Subject: CERTIFICATE OF COMPLIANCE NO. 9292 FOR THE MODEL NO. PATRIOT PACKAGE: Follow-up Information Requested during Conference Call Held June 2, 2005 - DOCKET No. 71-9292; TAC No. L23770

## Enclosure 1: Response to Follow-up Questions

# Application for Certificate of Compliance for the Patriot BWR Fuel Shipping Package

NRC Certificate of Compliance  
USA/9292/AF-85  
Docket 71-9292

Figure 1 USLs for 49 LWR-type fuel critical experiments,  $k_{eff}$  vs AEF (0.0 – 0.5 eV)

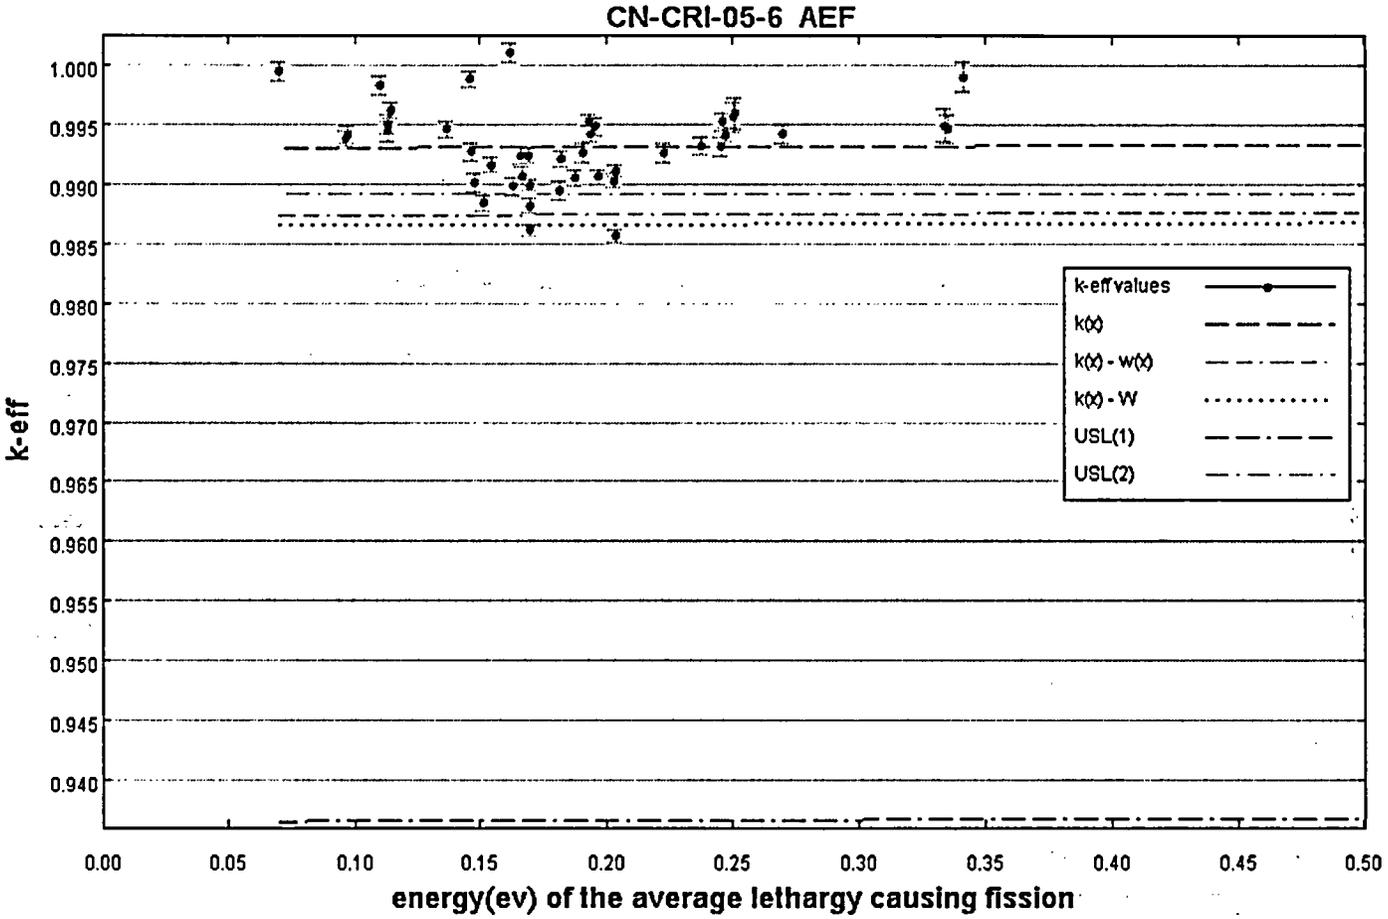
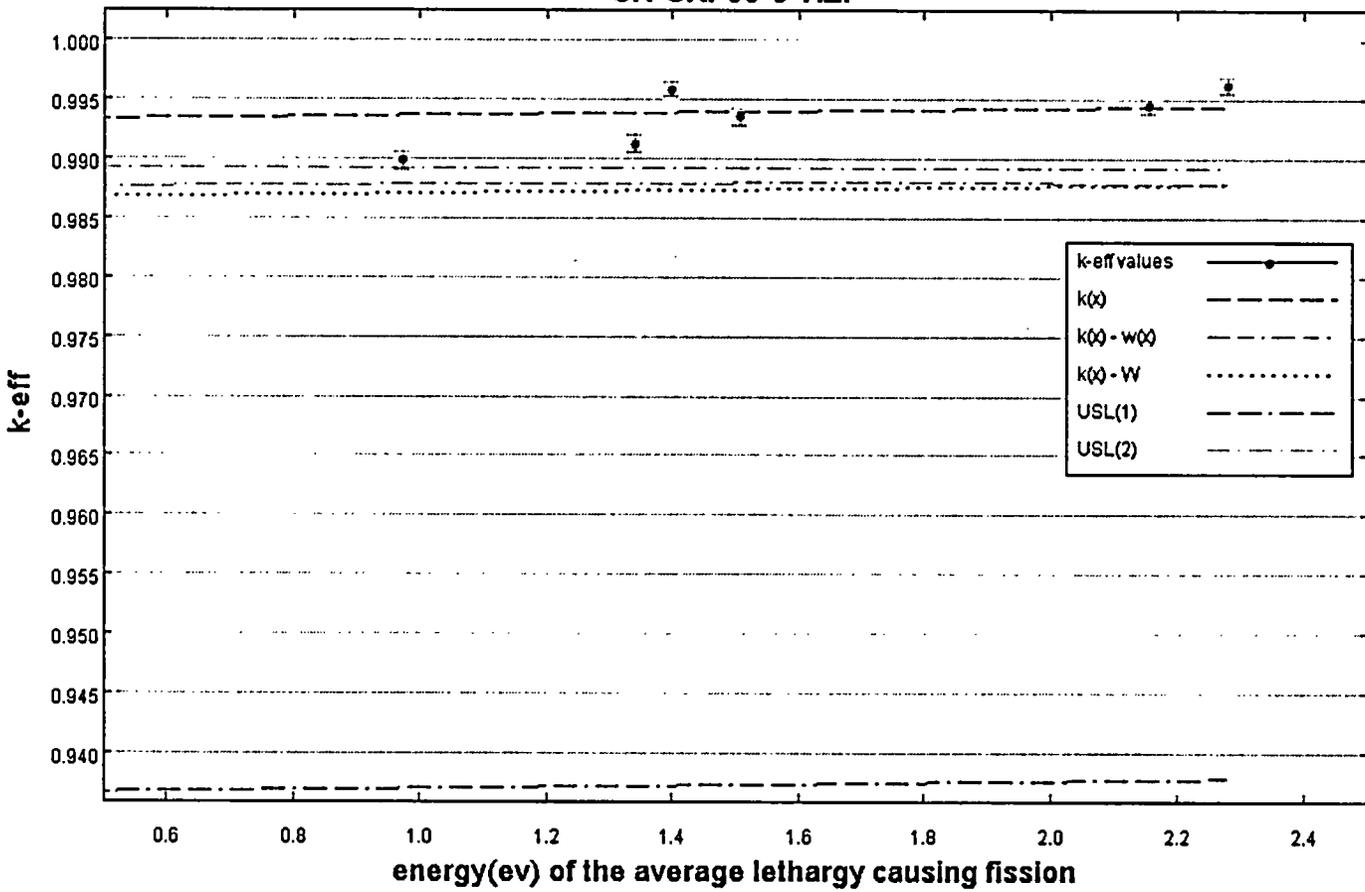
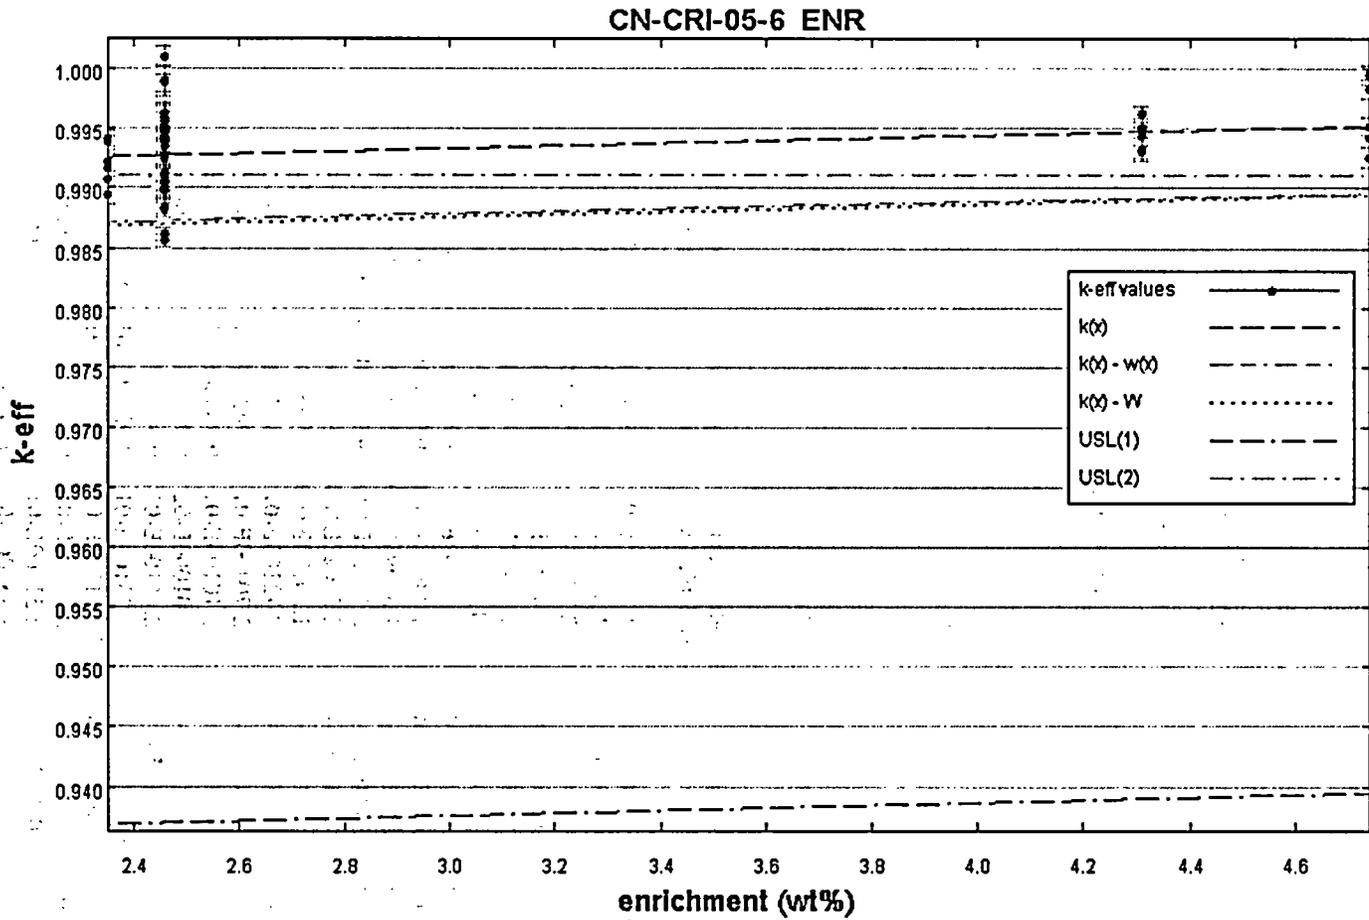
On page 6 of 13 in our RAI response (NMS-NRC-05-005) Westinghouse states,

“The energy (ev) of the average lethargy causing fission for the PATRIOT package that results in a maximum  $k_{eff}$  over the range of interspersed moderation densities and moderator configurations is approximately 0.6 ev. Only six of the critical benchmark critical experiments have EALF that is greater than 0.5 ev, but the *results show no significant trend in bias vs. energy. The largest bias results from a the correlation to the enrichment parameter*, and results in an upper safety limit of 0.9343 including a 0.05 arbitrary margin to ensure subcriticality.”

Provide trend data to substantiate these statements.

The USLSTATS output for AEF and ENR are provided to address the items above. Further, the data are graphed as follows:

- USLs for 49 LWR-type fuel critical experiments,  $k_{eff}$  vs AEF (0.0 – 0.5 eV),
- USLs for 49 LWR-type fuel critical experiments,  $k_{eff}$  vs AEF (0.5 - 2.5 ev), and
- USLs for 49 LWR-type fuel critical experiments,  $k_{eff}$  vs enrichment
